**TOWN OF MOUNTAIN VILLAGE
REGULAR DESIGN REVIEW BOARD MEETING
THURSDAY AUGUST 2, 2018 10:00 AM
2nd FLOOR CONFERENCE ROOM, MOUNTAIN VILLAGE TOWN HALL
455 MOUNTAIN VILLAGE BLVD, MOUNTAIN VILLAGE, COLORADO
AGENDA**

TO: Design Review Board
FROM: Sam Starr, Planner
FOR: Meeting of August 2, 2018
DATE: July 20, 2018
RE: Consideration of an Initial Architectural Site Review application for a new single-family dwelling on Lot 165 Unit 11, Cortina Drive

CORTINA LOT 11

ADDRESS MONUMENT

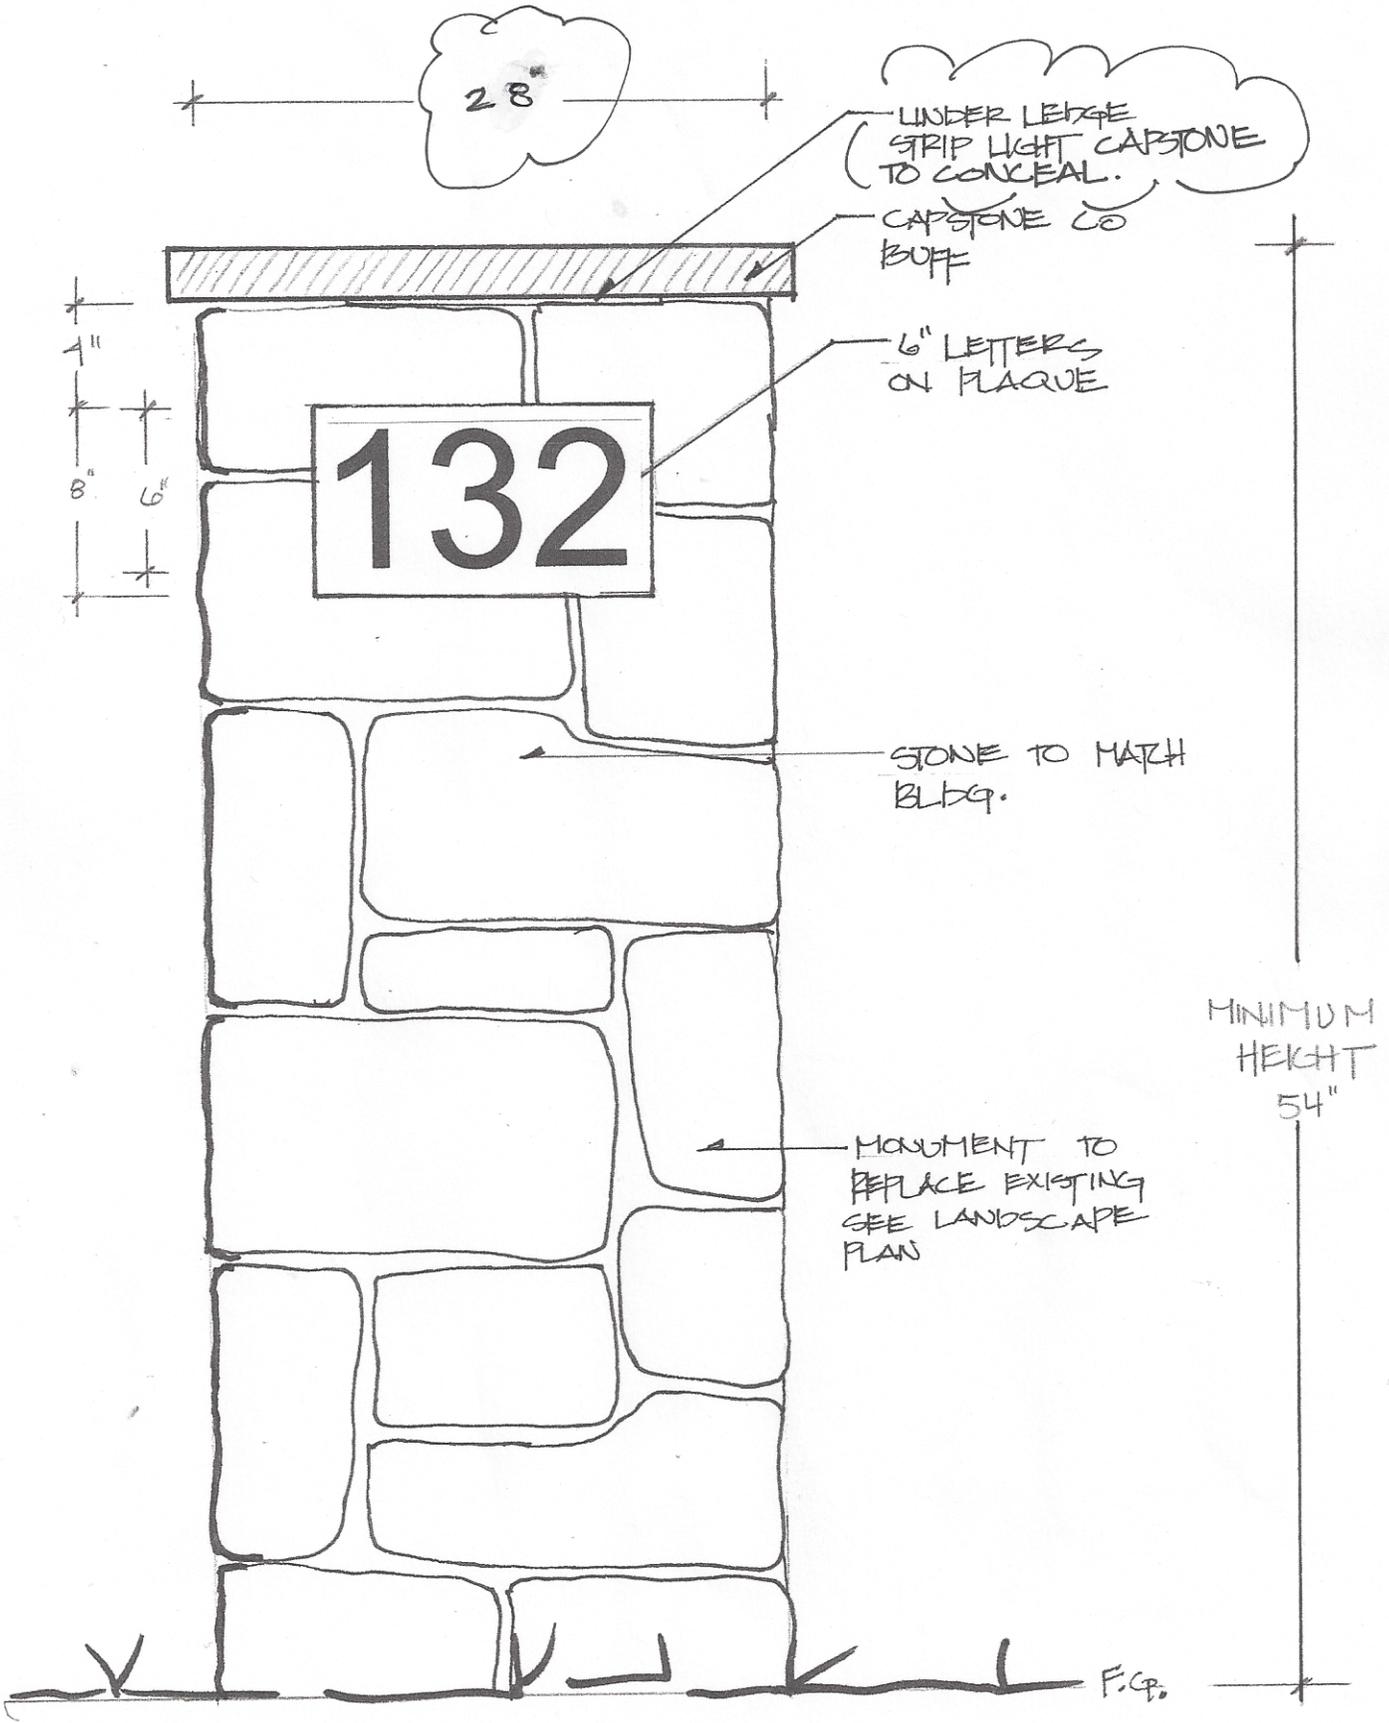
The town has been working with the owner on this issue and other compliance issues since November of 2017 to resolve matters. The owners have elected to bring a minor revisions application to the town to allow for the constructed address monument to remain, rather than the other two alternatives which could have been to modify the existing monument to conform to the CDC or remove and replace the monument with the DRB approved address monument. Staff has elevated this application to the DRB board because the request requires a number of design variations to be considered and/or approved.

The DRB can approve, deny or recommend a modification to the request to approve design variations and allow for the existing as-built monument to remain.

- If the DRB wishes to approve but modify the existing address monument staff recommends the height be reduced to the CDC requirement of no greater than 6 feet and remove “the bear house” from the metal fabricated address identification portion of the sign.
- If the DRB choose to approve as requested, that motion is straight forward.
- If the DRB chooses to deny the application, then applicant would need to remove and construct the address monument to the approved plan approved on September 7, 2017 and cite the findings and reasons as stated in the staff memo of record.

PRELIMINARY DRB GRADING AND DRAINAGE PLAN

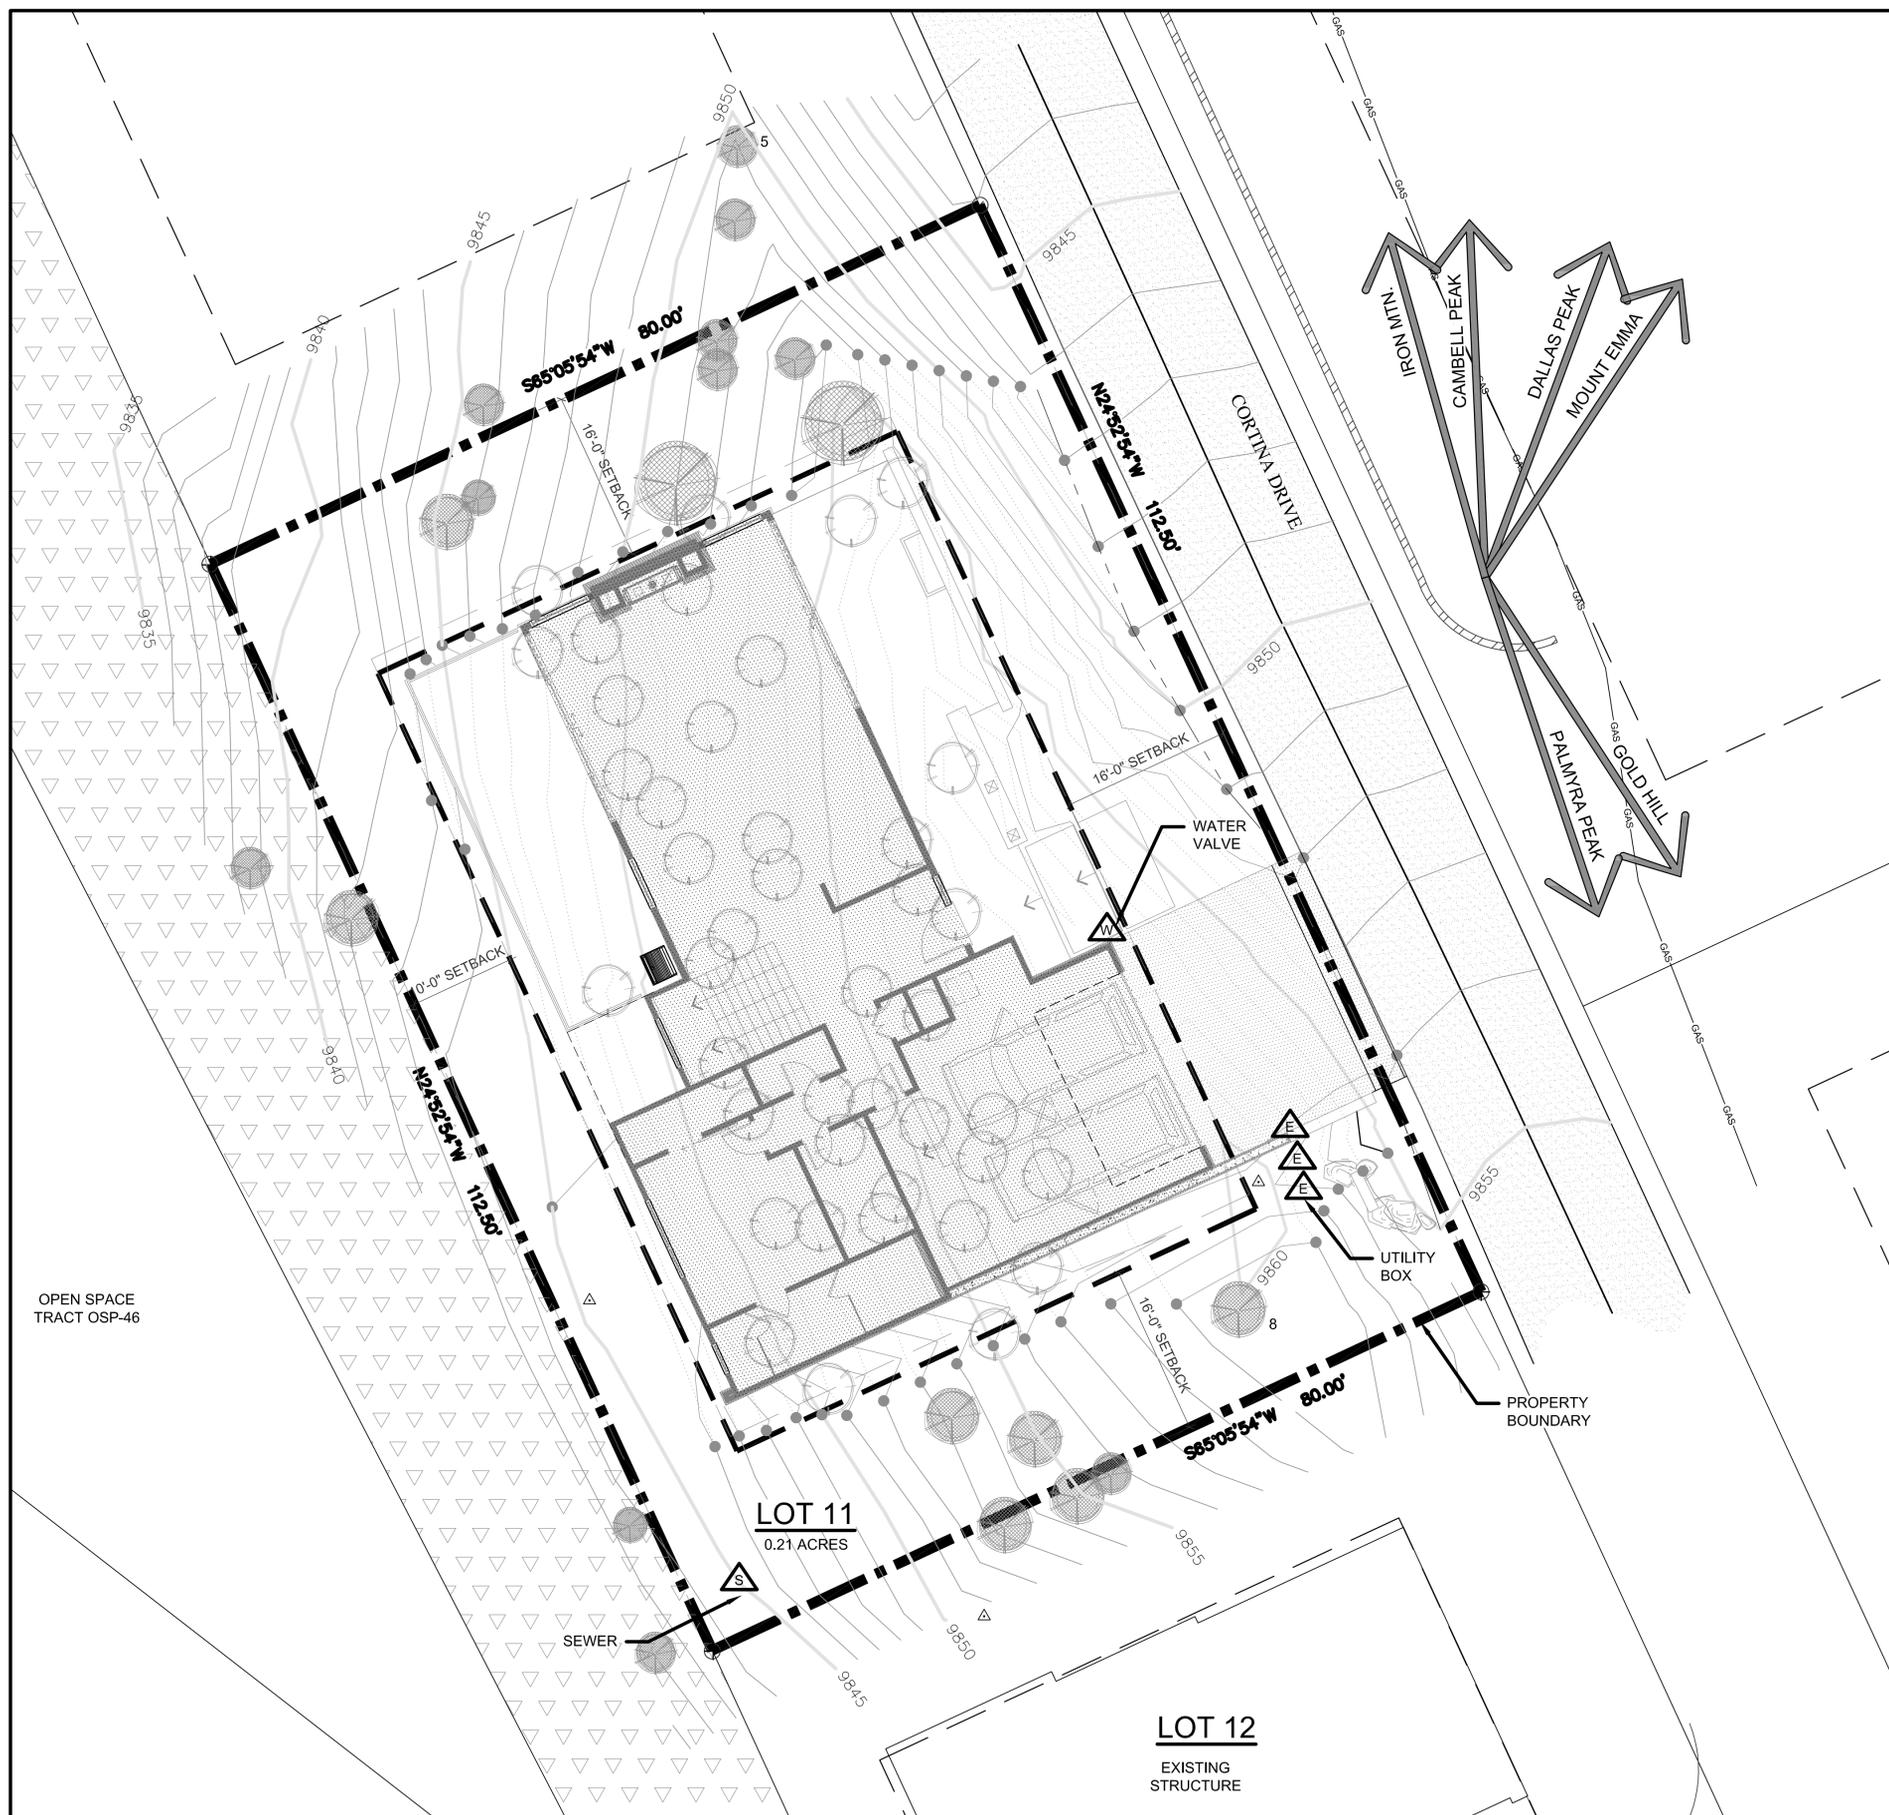
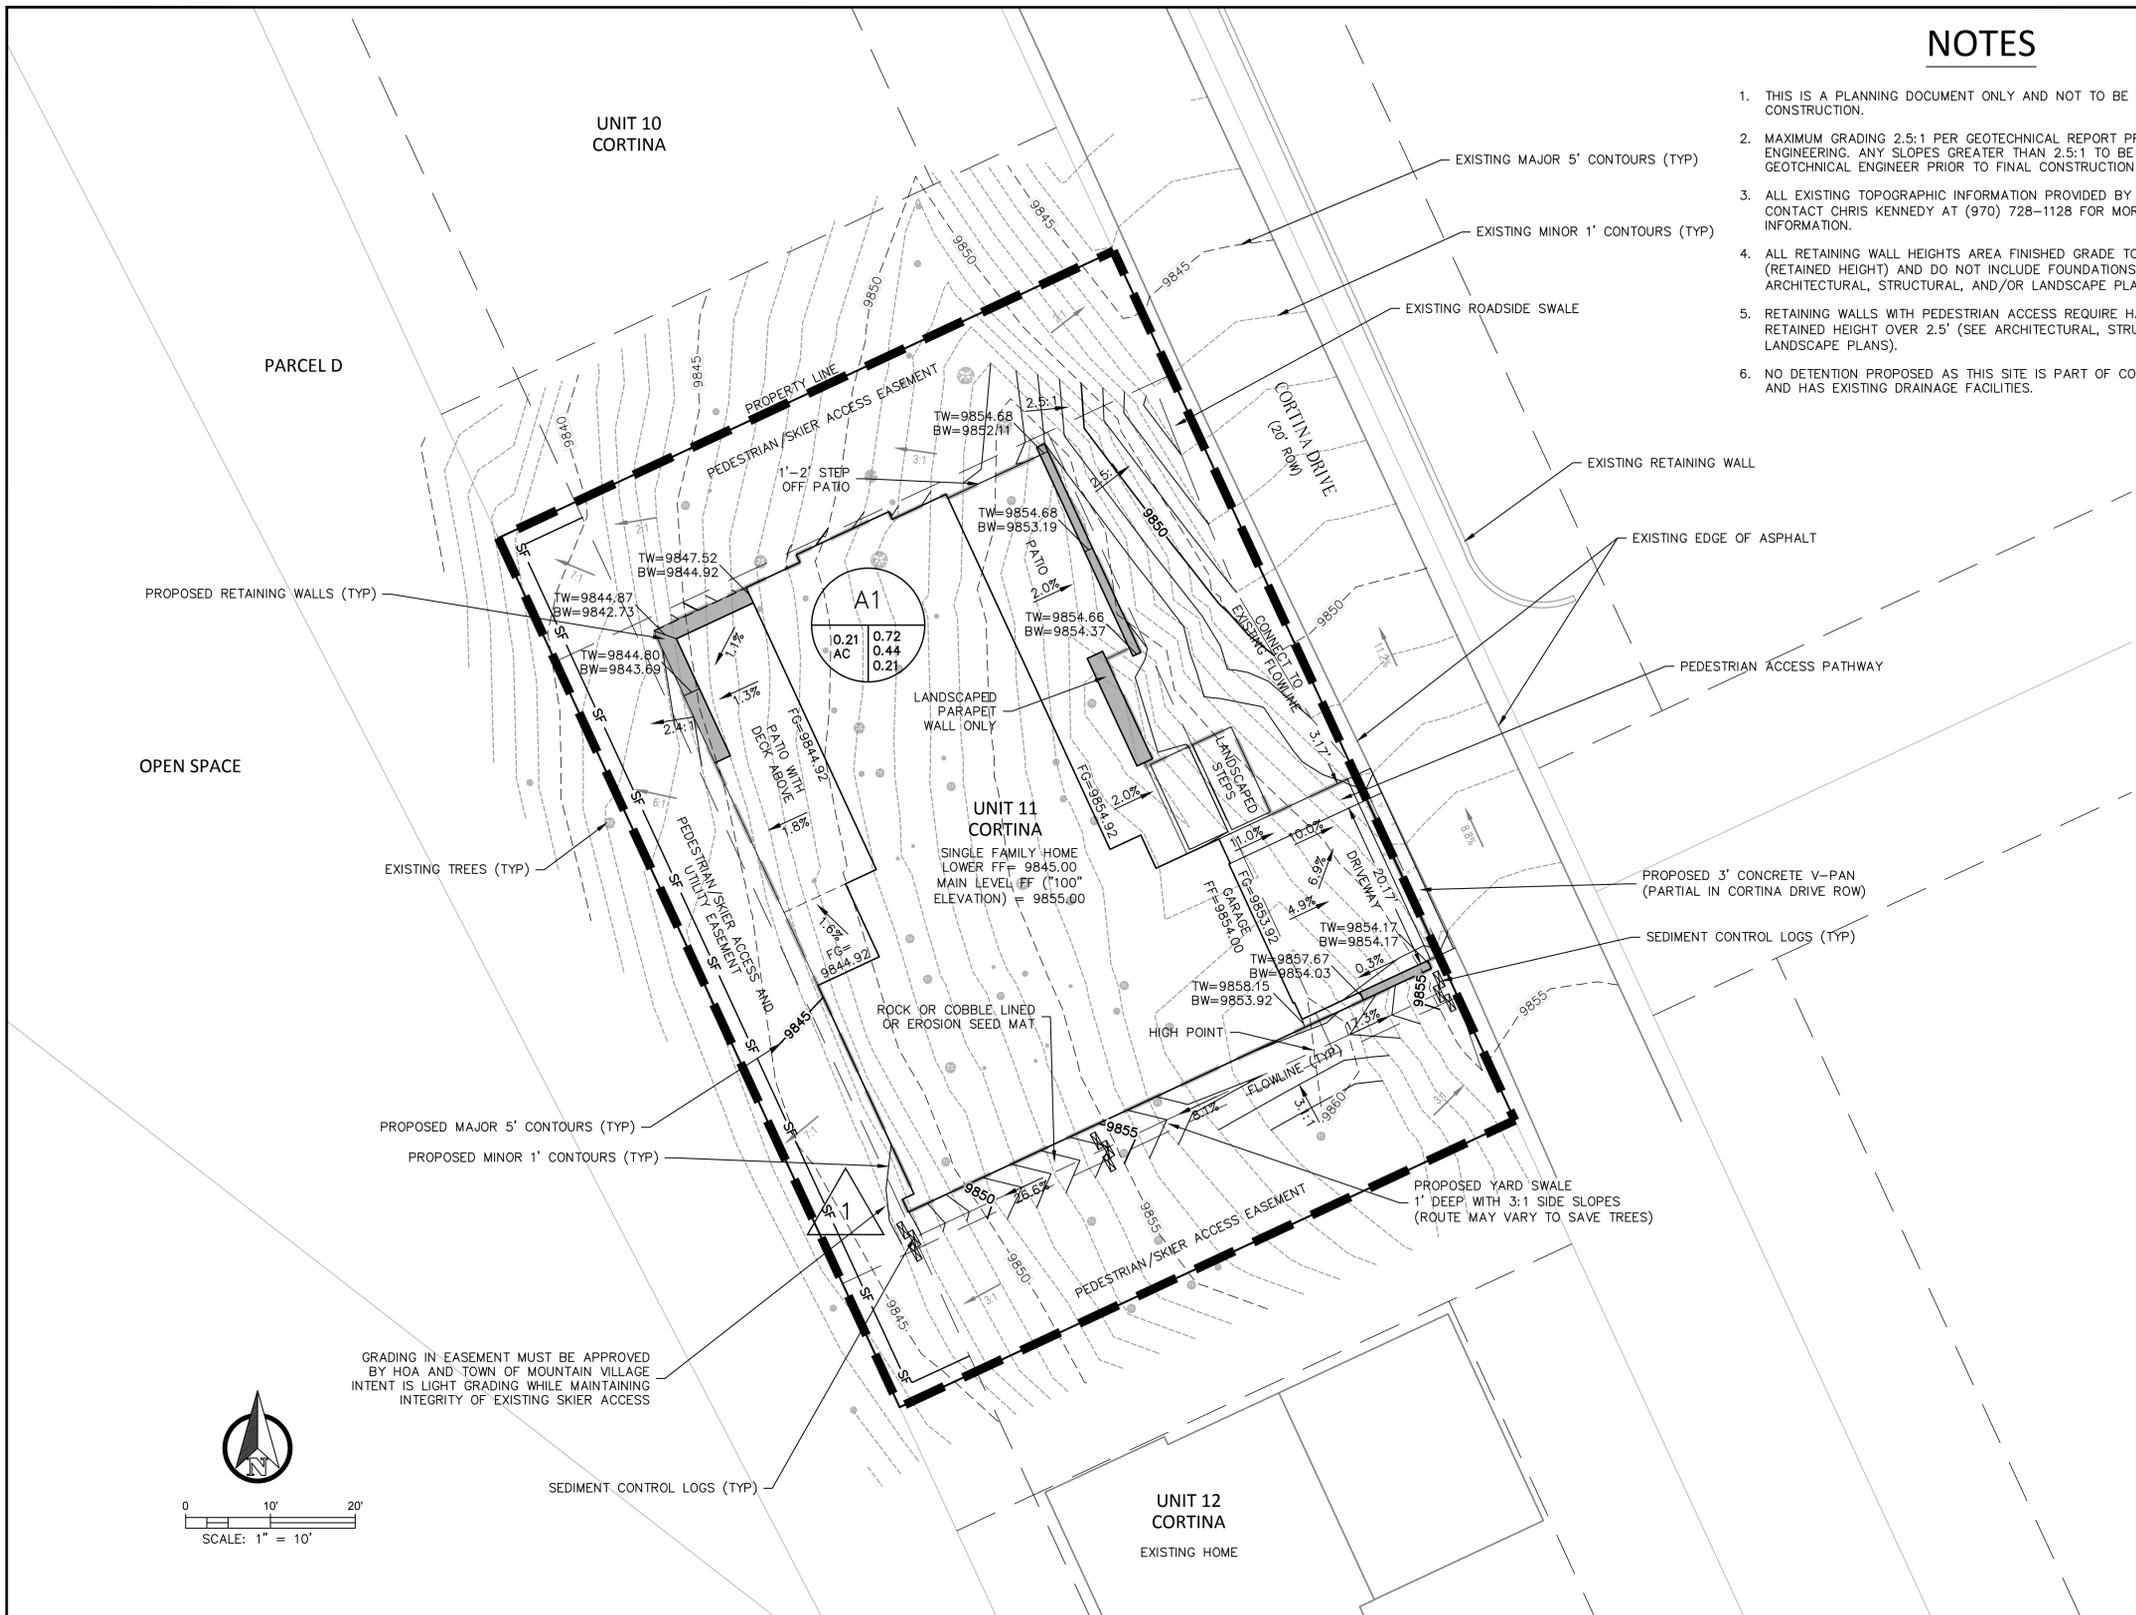
The applicant has provided a grading and drainage plan for the proposed development. Positive drainage away from the structures has been provided with all disturbed areas and to have final grades of 3:1 or flatter. The driveway and other fill areas will be graded with the foundation excavation. The applicant proposes to locate a portion of the driveway, and the 3 foot concrete v pan to be in the Cortina Drive road right of way.
